Informal Document **GRE-76-05**

**India's comments on WP.29 document  
ECE/TRANS/WP.29/2016/21, which is based on  
ECE-TRANS-WP29-GRE-2015-37e**

**Proposal for Supplement 18 to the original series of amendments to  
Regulation No. 50  
(Position, stop, direction indicators lamps for mopeds and motorcycles)**

**Sequential Direction indicators introduction in UN R 50**

*Annex 2, item 9., amend to read:*

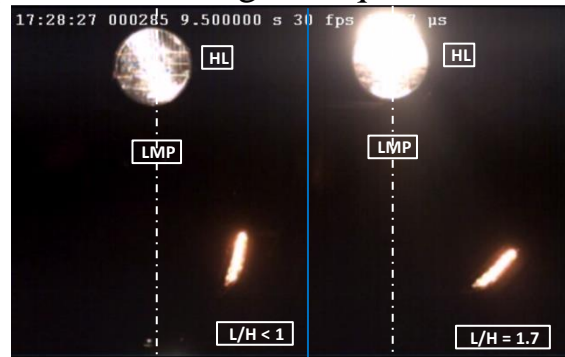
- "9. Concise description:3  
...  
Stop lamp: yes/ no 2  
Sequential activation of light sources (see paragraph 6.8. of this Regulation): yes/no 2 "
